# Dundee IF- ADA Evaluation

Report Date: 02/01/2024

**IF- Electra TX, Dundee ADA Evaluation**

**Accessibility Evaluation**

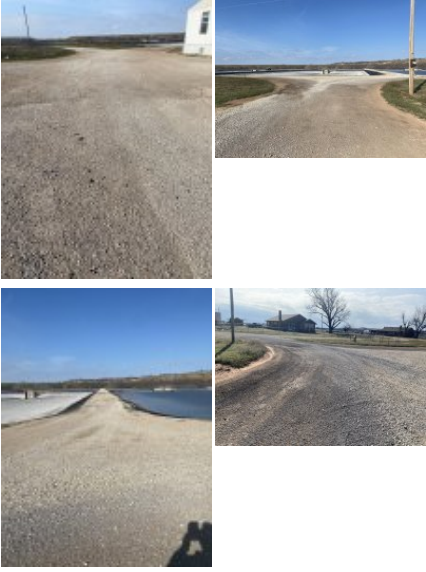
| Finding Number | Area Description  | Finding   | As Built   | Recommendation   | Citation  | Photos   | Figure  |
|----------------|---|---|--|--|---|--|---|
| 10             | Exterior of Property (Public): Holding Tanks (Exterior) - TOUR - Pathway to Holding Tanks | The path of contains multiple issues and is not accessible. The path of travel exceeds the maximum allowable cross and running slope requirements. It also contains changes in level and/or gaps that exceed the allowable maximum requirements. The path of travel does not meet the minimum width requirements for clearances, turning spaces, and/or passing spaces. The floor or ground surface is not firm, stable, and slip resistant.  | Due to terrain and change in elevation this element is not accessible. Packed earth is not considered a compliant surface. | Review accessible pathway componets to make accessible <a href="https://www.access-board.gov/ada/#ada-402">https://www.access-board.gov/ada/#ada-402</a> <a href="https://www.access-board.gov/ada/#ada-403_1">https://www.access-board.gov/ada/#ada-403_1</a>   | 2010 ADAS Section: 403.1<br><br>2015 ABAAS Section: 403.1                                       |  |   |

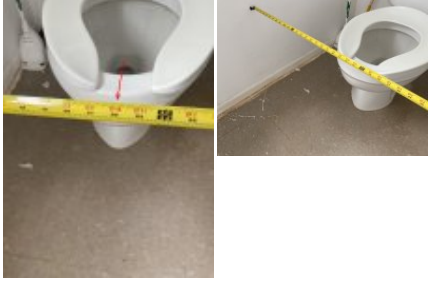
| Finding Number | Area Description   | Finding   | As Built  | Recommendation  | Citation   | Photos  | Figure  |
|----------------|--|---|---|---|--|---|---|
| 13             | Exterior of Property (Public): Pathway to Holding Ponds - TOUR | The accessible route contains loose gravel and/or surface materials that do not provide for a stable, firm slip resistant surface. Floor and ground surfaces shall be stable, firm, and slip resistant. | The accessible route to holding pond is not compliant due to loose gravel and gravel size.. | <a href="https://www.access-board.gov/ada/#ada-302_1">https://www.access-board.gov/ada/#ada-302_1</a> | 2012 TAS Section: 302.1<br>2010 ADAS Section: 302.1<br>2015 ABAAS Section: 302.1 |  |  |

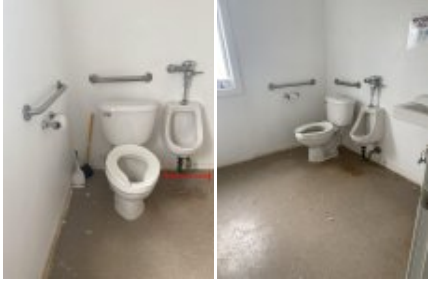
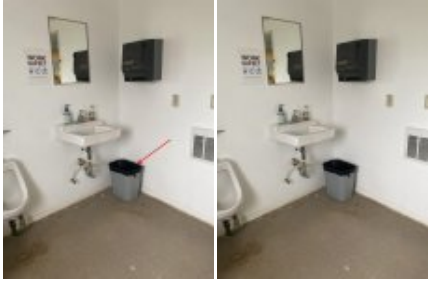
| Finding Number | Area Description   | Finding   | As Built  | Recommendation  | Citation  | Photos  | Figure  |
|----------------|--|---|---|---|---|---|---|
| 16             | Structures on Property (Public)<br>- Tour/Public Componets :<br>Shop/Public Restrooms (Interior) - Entrance/Exit Doors | The tactile EXIT sign is missing at the door. Wall signs identifying exits shall have characters raised 1/32 inch minimum and shall be uppercase characters a minimum of 5/8 inch and a maximum of 2 inches high. Braille shall be placed directly below the tactile characters; flush left or centered. Signs shall be located a minimum of 48 inches above the floor, measured from the baseline of the lowest tactile characters and 60 inches maximum above the finish floor or ground surface, measured from the baseline of the highest tactile characters. Where a tactile sign is provided at a door, the sign shall be located on the latch side. Where a tactile sign is provided at double doors the sign shall be located to the right of the right-hand door. Where there is no wall space at the latch side of a single door or at the right side of double doors, signs shall be located on the nearest adjacent wall. | Secondary entrance<br>Where visual EXIT is provided, accompanying tactile EXIT sign must also be provided for same doorway. Doorway exit signs and emergency exits with emergency exit signs that are overhead or visual only, or pictograms only, must have an accompanying ADA Braille sign. Exit passages, including doors, stairs and routes, must be identified with tactile ADA signage. Signs must include braille and raised characters. Pictograms are optional. | <a href="https://www.access-board.gov/ada/#ada-216_4_1">https://www.access-board.gov/ada/#ada-216_4_1</a> | 2012 TAS Section: 216.4.1<br><br>2010 ADAS Section: 216.4.1<br><br>2015 ABAAS Section: F216.4.1 |  |  |

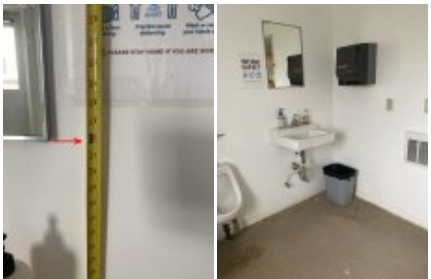
| Finding Number | Area Description   | Finding   | As Built  | Recommendation   | Citation  | Photos  | Figure  |
|----------------|--|---|---|--|---|---|---|
| 17             | Structures on Property (Public)<br>- Tour/Public Componets :<br>Shop/Public Restrooms (Interior) - Restroom (Unisex) | The restroom is not nearly compliant. The restroom does not have the required minimum clear floor space or maneuvering clearances for the toilet. The restroom does not have the required minimum clear floor space or maneuvering clearances for the lavatory. The entry door does not contain the required minimum maneuvering spaces on the pull/push sides. The entry door encroach into the required clear floor space for fixtures. Grab bars are missing and/or incorrectly installed. Accessories, such as toilet seat covers, paper towel holders, garbage cans, hand dryers, and mirrors are either too high or without clear floor space or both. The restroom contain floor level changes greater than a 1/2 inch of the floor drains and is slope (XX) - (XX), the shower is too small and missing numerous accessible elements. | This restroom requires a number of componets to gain compliance. Currently there is 1 unisex and 1 women's restroom provided. | <a href="https://www.access-board.gov/ada/#ada-213_2">https://www.access-board.gov/ada/#ada-213_2</a><br>Review restrooms componets to make accessible.<br><a href="https://www.access-board.gov/ada/#ada-603">https://www.access-board.gov/ada/#ada-603</a> | 2012 TAS Section: 213.2<br><br>2010 ADAS Section: 213.2<br><br>2015 ABAAS Section: F213.2 |    |    |

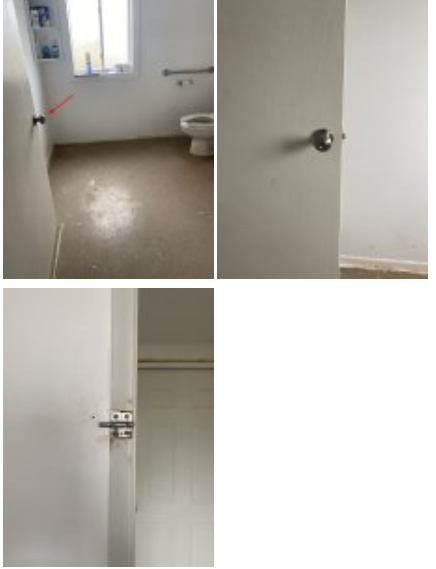
| Finding Number | Area Description   | Finding   | As Built                                | Recommendation | Citation  | Photos   | Figure |
|----------------|--|---|---|----------------|---|--|--------|
| 22             | Structures on Property (Public)<br>- Tour/Public Componets :<br>Shop/Public Restrooms (Interior) - Restroom (Unisex) | The toilet paper is not installed within the compliant range. Toilet paper dispensers shall be 7 inches minimum and 9 inches maximum in front of the water closet measured to the centerline of the dispenser. The outlet of the dispenser shall be 15 inches minimum and 48 inches maximum above the finish floor and shall not be located behind grab bars. Dispensers shall not be of a type that controls delivery or that does not allow continuous paper flow. There shall be a clearance of 1 1/2 inches minimum below the grab bar. | TP dispenser location is not compliant. |                | <a href="https://www.access-board.gov/ada/#ada-604_7">https://www.access-board.gov/ada/#ada-604_7</a>     | 2012 TAS Section: 604.7<br><br>2010 ADAS Section: 604.7<br><br>2015 ABAAS Section: 604.7       |        |

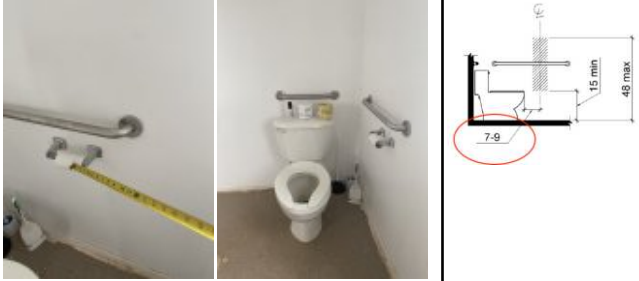
| Finding Number | Area Description   | Finding  | As Built                                | Recommendation | Citation  | Photos   | Figure   |  |
|----------------|--|--|---|----------------|---|--|--|--|
| 28             | Structures on Property (Public)<br>- Tour/Public Componets :<br>Shop/Public Restrooms (Interior) - Restroom (Unisex) | The mirror is mounted above the allowable height above the lavatory and/or counter. Mirrors must have the bottom edge of the reflecting surface a maximum of 40 inches above the floor if above a sink or counter. Mirrors not located above lavatories or countertops shall be installed with the bottom edge of the reflecting surface 35 inches maximum above the finish floor or ground. | Over 47"                                |                | <a href="https://www.access-board.gov/ada/#ada-603_3">https://www.access-board.gov/ada/#ada-603_3</a> | 2012 TAS Section: 603.3<br><br>2010 ADAS Section: 603.3<br><br>2015 ABAAS Section: 603.3 |  |  |

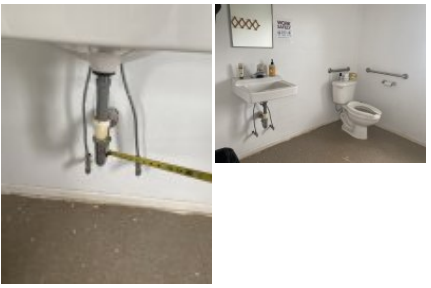
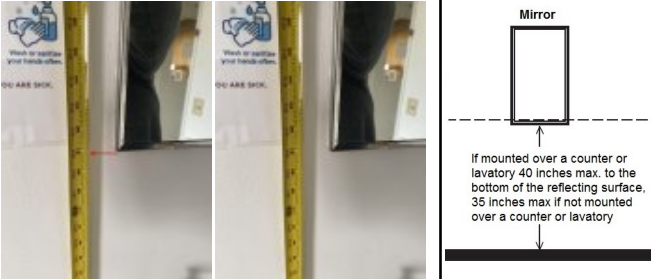
| Finding Number | Area Description  | Finding   | As Built  | Recommendation   | Citation   | Photos   | Figure |
|----------------|---|---|---|--|--|--|--------|
| 32             | Structures on Property (Public)<br>- Tour/Public Componets :<br>Shop/Public Restrooms (Interior) - Restroom (Women's) | The restroom is not nearly compliant. The restroom does not have the required minimum clear floor space or maneuvering clearances for the toilet. The restroom does not have the required minimum clear floor space or maneuvering clearances for the lavatory. The entry door does not contain the required minimum maneuvering spaces on the pull/push sides. The entry door encroach into the required clear floor space for fixtures. Grab bars are missing and/or incorrectly installed. Accessories, such as toilet seat covers, paper towel holders, garbage cans, hand dryers, and mirrors are either too high or without clear floor space or both. The restroom contain floor level changes greater than a 1/2 inch of the floor drains and is slope (XX) - (XX), the shower is too small and missing numerous accessible elements. | This restroom requires a number of componets to gain compliance. Currently there is 1 unisex and 1 women's restroom provided. | <a href="https://www.access-board.gov/ada/#ada-213_2">https://www.access-board.gov/ada/#ada-213_2</a><br>Review restrooms componets to make accessible.<br><a href="https://www.access-board.gov/ada/#ada-603">https://www.access-board.gov/ada/#ada-603</a> | 2012 TAS Section: 213.2<br><br>2010 ADAS Section: 213.2<br><br>2015 ABAAS Section: F213.2      |  |        |

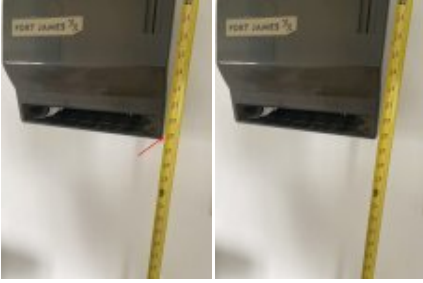
| Finding Number | Area Description  | Finding   | As Built                          | Recommendation  | Citation   | Photos | Figure |
|----------------|---|---|-----------------------------------|---|--|--------|--------|
| 35             | Structures on Property (Public)<br>- Tour/Public Componets :<br>Shop/Public Restrooms (Interior) - Restroom (Women's) | The rear grab bar is not a minimum 36 inches in length. Grab bars shall be installed in a horizontal position, 33 inches minimum and 36 inches maximum above the finish floor measured to the top of the gripping surface and the space between the grab bar and the top of the tank (any obstruction) shall be 1-1/2 inches minimum.   | Rear grab bar less than 36" long. | <a href="https://www.access-board.gov/ada/#ada-604_5_2">https://www.access-board.gov/ada/#ada-604_5_2</a> | 2012 TAS Section: 604.5.2<br><br>2010 ADAS Section: 604.5.2<br><br>2015 ABAAS Section: 604.5.2 |        |        |

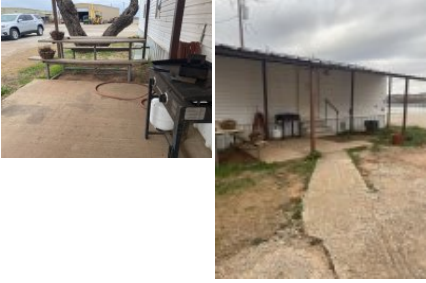
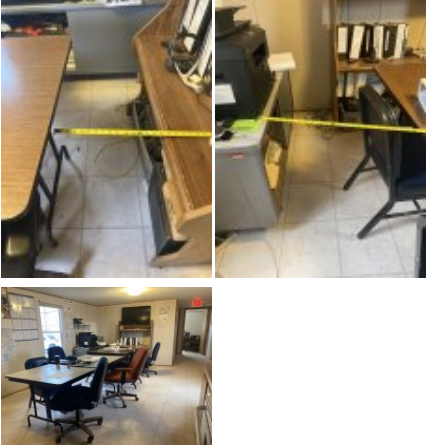
| Finding Number | Area Description  | Finding  | As Built                                    | Recommendation   | Citation                    | Photos  | Figure  |
|----------------|---|--|---|--|-----------------------------|---|---|
| 51             | Structures on Property (Public)<br>- Tour/Public Componets : Raceway/Production Area - TOUR | State and local governments have an obligation to make their programs and services accessible to persons with disabilities. This may or may not require the alteration, addition or construction of existing facilities which predate The Americans with Disabilities Act (ADA) of 1990. Under the Code of Federal Regulations Section 35.151(b)(2) State and Local Government Title II entities may provide programmatic access where alterations to existing facilities would result in undue financial and administrative burdens. For Example, A public entity has six courtrooms in two existing buildings and determines that only three of those courtrooms and the public use and common use areas serving those courtrooms in one building are needed to be made accessible in order to satisfy its program access obligations. The entity must comply with 2010 Standards unless compliance would result in undue financial and administrative burdens and must take other actions that would not result in an undue financial burden to ensure access to persons with disabilities. This may include the scheduling of the various types of cases, hearings etc. in accessible courtrooms and relocating them where necessary to accommodate persons with disabilities. Having a defined program and effective communication process in place to ensure the public and employees can request accommodations is necessary to ensure equal access to the county's court system. Program access is not part of this evaluation and this information is being provided as an advisory only. | No way to access this element at this time. | Provide a reasonable modification to allow tour participants an equitable experience during this part of tour. | 2010 ADAS Section: Advisory |  |  |

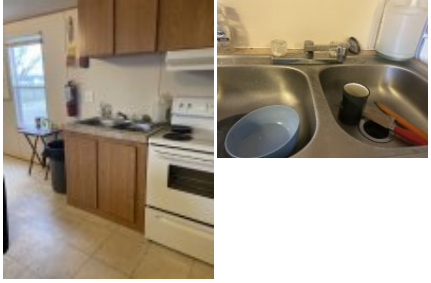
| Finding Number | Area Description   | Finding   | As Built  | Recommendation   | Citation   | Photos  | Figure  |
|----------------|--|---|---|--|--|---|---|
| 52             | Structures on Property (Public)<br>- Tour/Public Components : Raceway/Production Area - TOUR | The accessible route contains loose gravel and/or surface materials that do not provide for a stable, firm slip resistant surface. Floor and ground surfaces shall be stable, firm, and slip resistant. | Route has narrow passageway, loose gravel, large gaps, elevation changes. | Accessible route should be made to outsides of raceway tanks to increase accessibility.<br><a href="https://www.access-board.gov/ada/#ada-302_1">https://www.access-board.gov/ada/#ada-302_1</a> | 2012 TAS Section: 302.1<br><br>2010 ADAS Section: 302.1<br><br>2015 ABAAS Section: 302.1 |  |  |

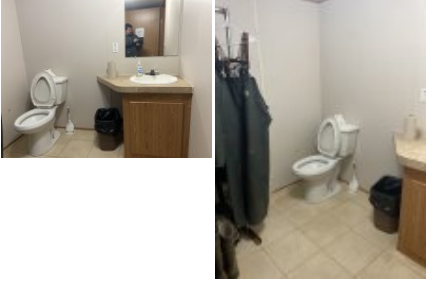
| Finding Number | Area Description  | Finding   | As Built   | Recommendation   | Citation  | Photos   | Figure  |
|----------------|---|---|--|--|---|--|---|
| 58             | Structures on Property (STAFF): Staff Work Trailer (Interior) - Conference Room/Kitchenette | Knee and toe space has not been provided at the sink. Kitchen sinks must be provided with a clear floor space positioned for a forward approach including knee and toe clearance.   | Knee and toe must be provided since kitchenette contain stove top range. | <a href="https://www.access-board.gov/ada/#ada-606_2">https://www.access-board.gov/ada/#ada-606_2</a><br><a href="https://www.access-board.gov/ada/#ada-804_4">https://www.access-board.gov/ada/#ada-804_4</a> | 2012 TAS Section: 606.2, 804.4<br><br>2010 ADAS Section: 606.2, 804.4<br><br>2015 ABAAS Section: 606.2, 804.4 |   |  |
